Response to Observations

Knockshanvo Wind Farm Co.
Clare

An Coimisiún Pleanála Ref
No: 320705-24

Document Title: **Knockshanvo Wind Farm - Response to Observations F**

Figure 1 Extracted imagery and location map for Viewpoint VP13 from the Volume 2 Photomontage Booklet

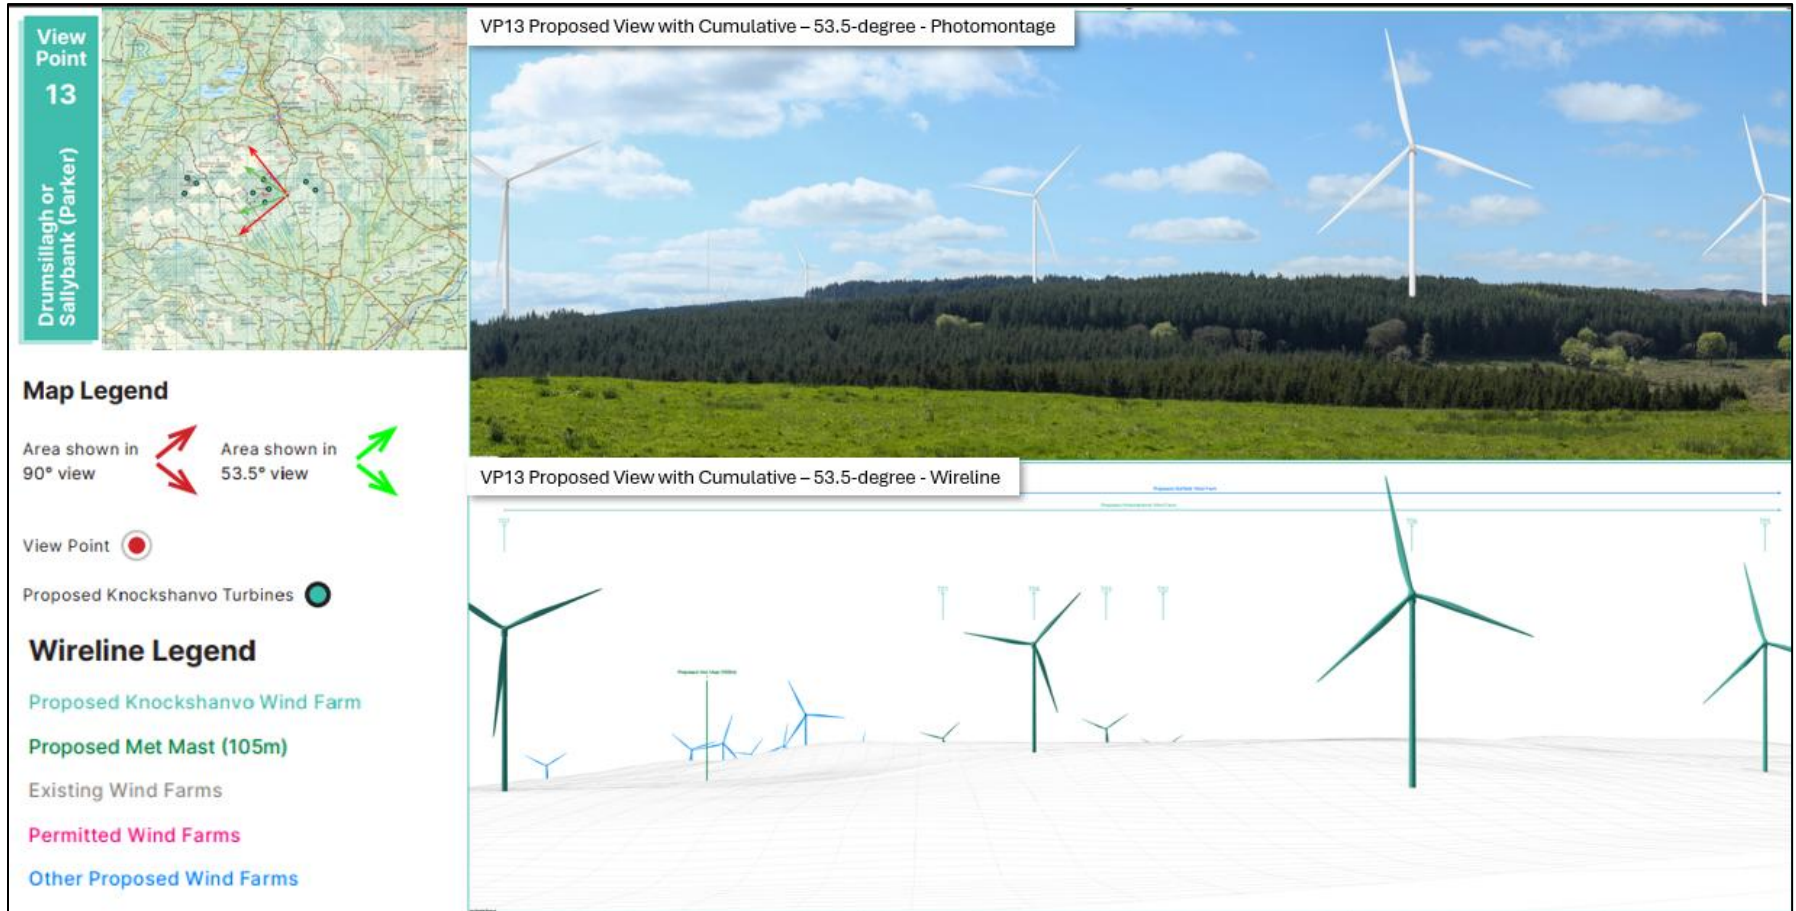
It is to be anticipated that wind farms inevitably have the potential to cause some “Significant” visual effects on proximate visual receptors due to the prominence of turbines within landscape views and the “Substantial” magnitude of change (EPA 2022) which will arise in close proximity to a wind farm development. For effects on locally sensitive receptors such as residential properties, mitigation measures can be implemented. In the case of the Proposed Development, these measures are discussed throughout Sections **Error! Reference source not found.** through 3.1.13.4 of this response, and an example is given below with respect to mitigating factors reported for viewpoint VP13.

VP13 Drumsillagh or Sallybank (Parker) is located 800m east from proposed turbine T6 (see extracted image from the *Volume 2 Photomontage Booklet* below, Error! Reference source not found.) and was captured to represent receptors deemed High sensitivity because of their close proximity to the Wind Farm Site.

VP13 shows the highest degree of visibility possible for receptors in this area (see *Volume 2 Photomontage Booklet* and corresponding visual impact assessment reported in *Appendix 14-3*). The predicted residual visual effects are “Significant” (EPA, 2022) on account of the “Substantial” magnitude of change which may be experienced by receptors in this area. For the avoidance of doubt, this viewpoint was selected to show the level of predicted effects as the worst-case scenario and the effects are not anticipated to be experienced by most receptors in the area.
